Preliminary Consultation = '96
Ponkaoni/Brode LLC
9310 Bunker Hill Rd. Lots 47, 48

9310 Brooklyn Rd
For Law HPC 7/24/96
(pursuant)

Ref: Public Hearing on Preliminary Plan #1-96078 (Linden) Scheduled for April 25, 1996

SITE PLAN
 LOTS 46, 47, AND 48
 A RESUBDIVISION OF PART OF LOT-1
LINDEN
 13th ELECTION DISTRICT MONTGOMERY COUNTY, MARYLAND
 SCALE: 1"=50' JULY, 1996

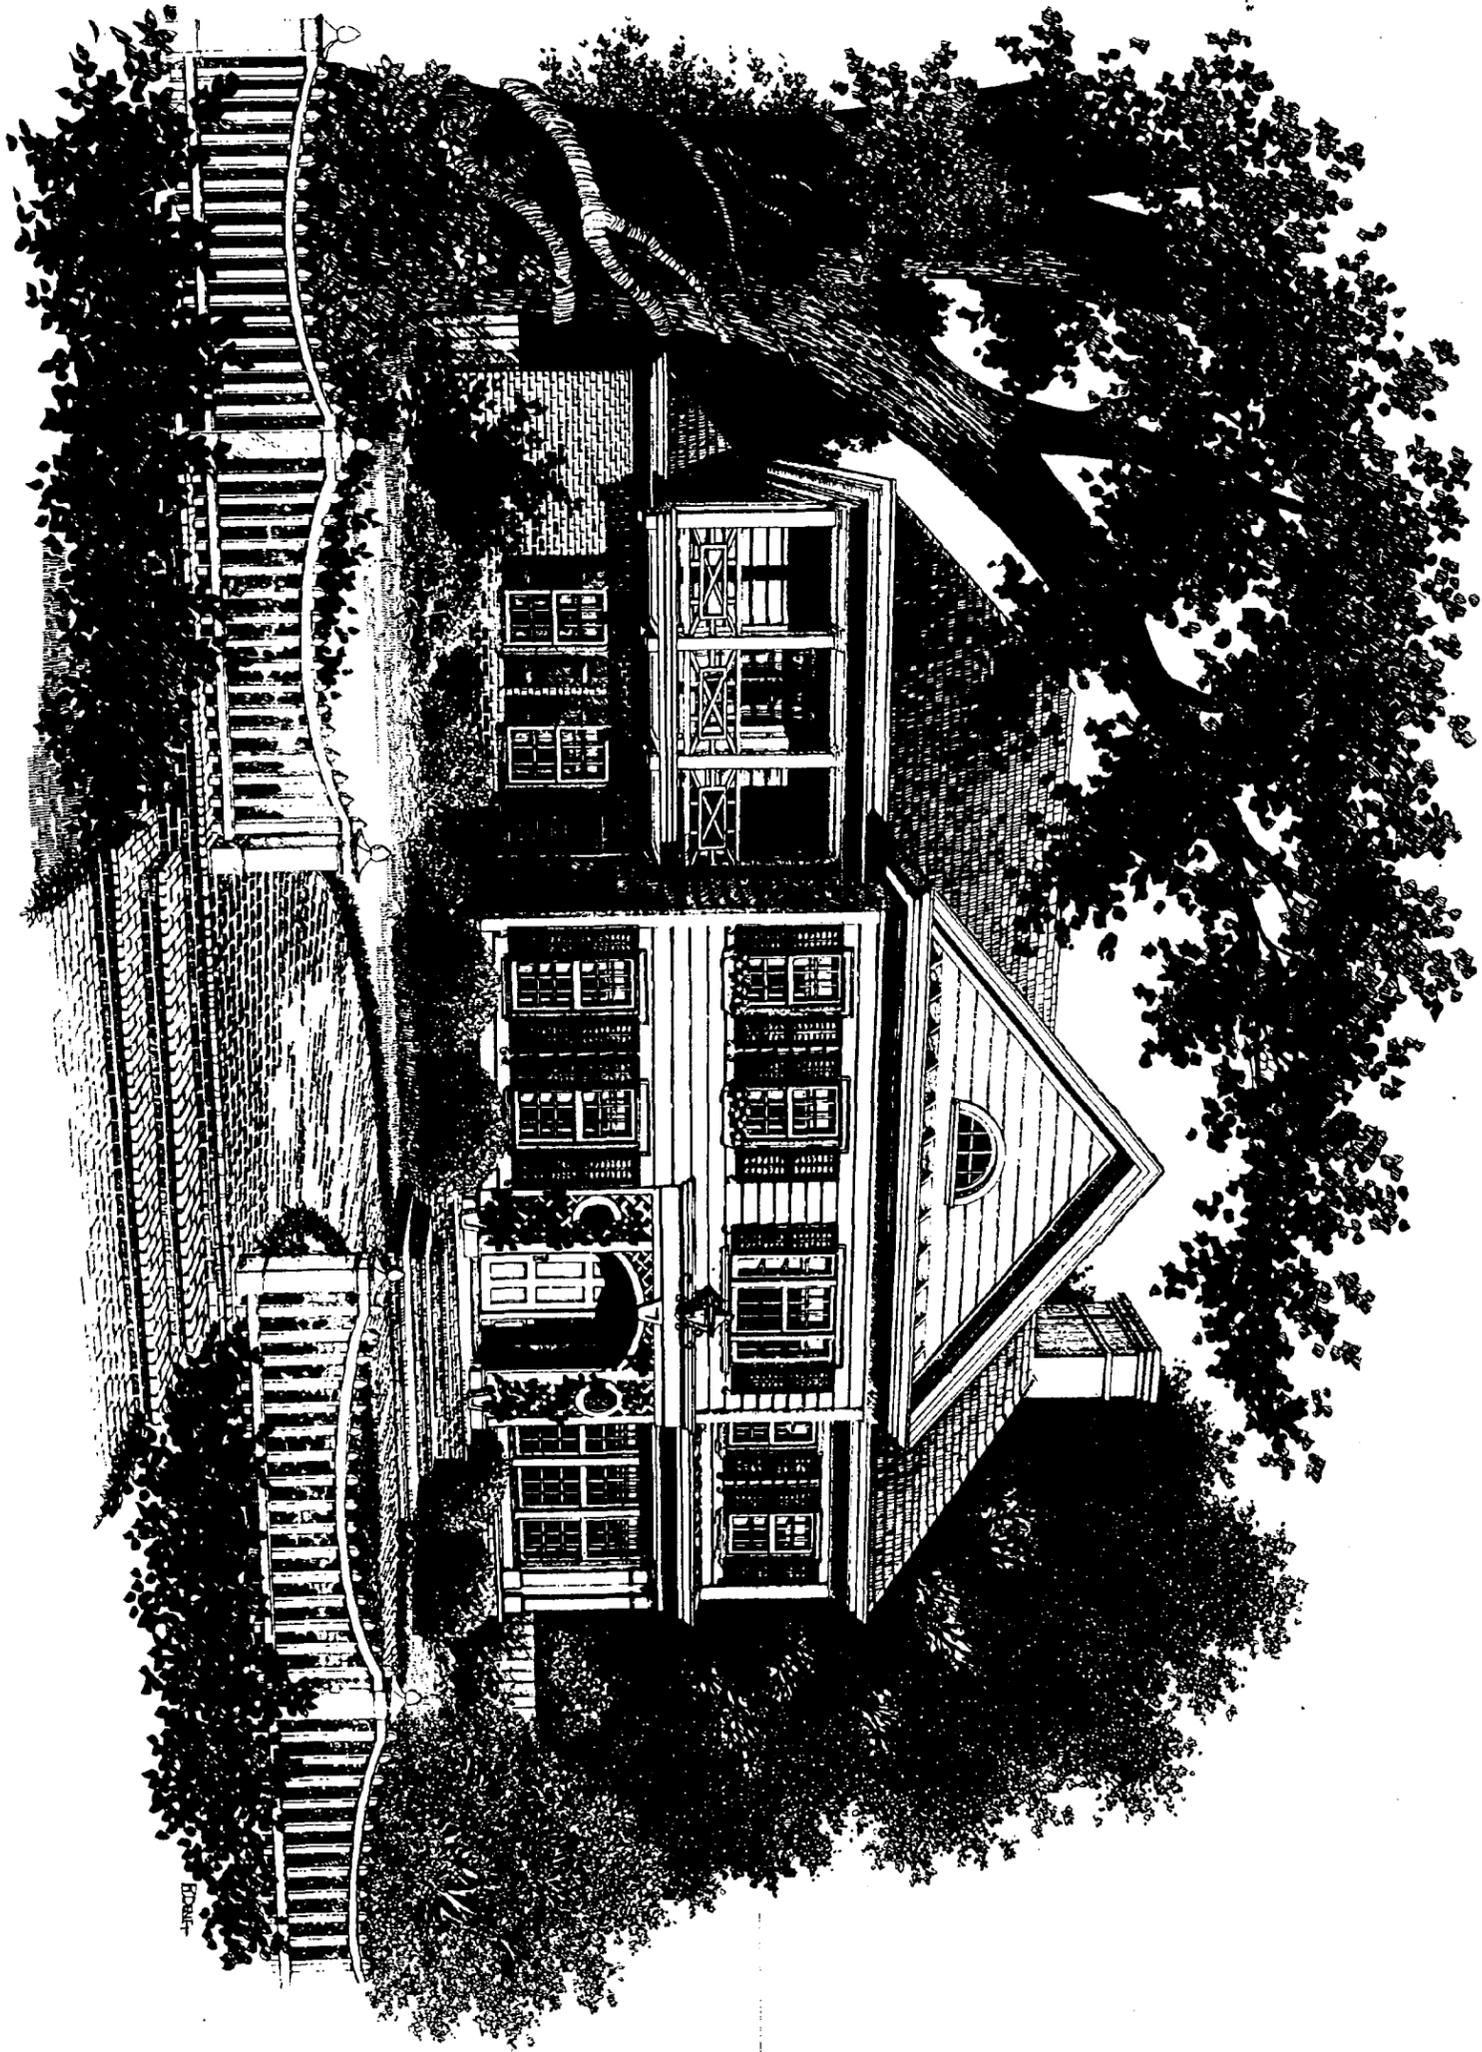
I have two (2) strong objections to the staff report. First, the report recommends that the house on Lot 47 be located as far East as possible. This will result in less than 25' of separation to our house. Although the developer has agreed to install a privacy fence between our properties 25' is insufficient. There is ample room to widen this space without losing what the report refers to as "spectacular shrub and tree specimens". We request that the house on Lot 47 be located not less than 25' from the property line which will provide approximately 32' of separation house to house.

The second objection concerns the staff recommendation to eliminate garages for the two new houses. This will undoubtedly result in lower priced houses which, in turn, impacts the value of adjacent property. In addition, without garages the esthetics desired by the staff will be lost as the open space becomes a parking lot.
